Notice of Allowability	Application No.	Applicant(s)	
	10/714,965	HUANG, WEI-CHIA	
	Examiner	Art Unit	
	Ernesto Garcia	3679

EXAMINER'S AMENDMENT

FIG. 6

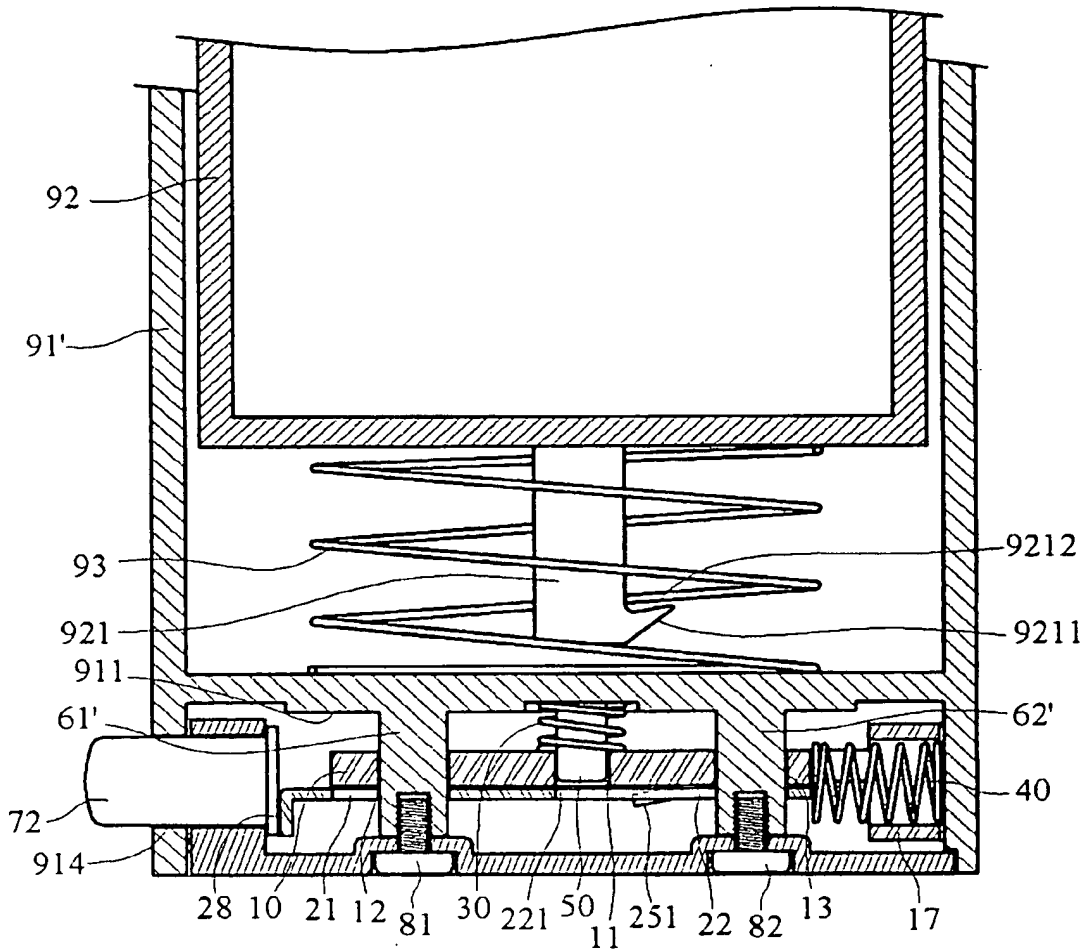
The following changes to the drawings have been approved by the examiner and agreed upon by applicant: the cross hatching of the guide plate 10 and the locking plate 20 is incorrect in Figures 2, 4A-4F, 6, and 8A-8F. It was agreed that the cross hatching of the guide plate be changed to plastic according to page 6, line 9 of the specification, and the cross hatching of the locking plate be changed to metal according to page 6, line 13 of the specification. In order to avoid abandonment of the application, applicant must make these above agreed upon drawing changes.

Accepted
 GL. #12/27/03
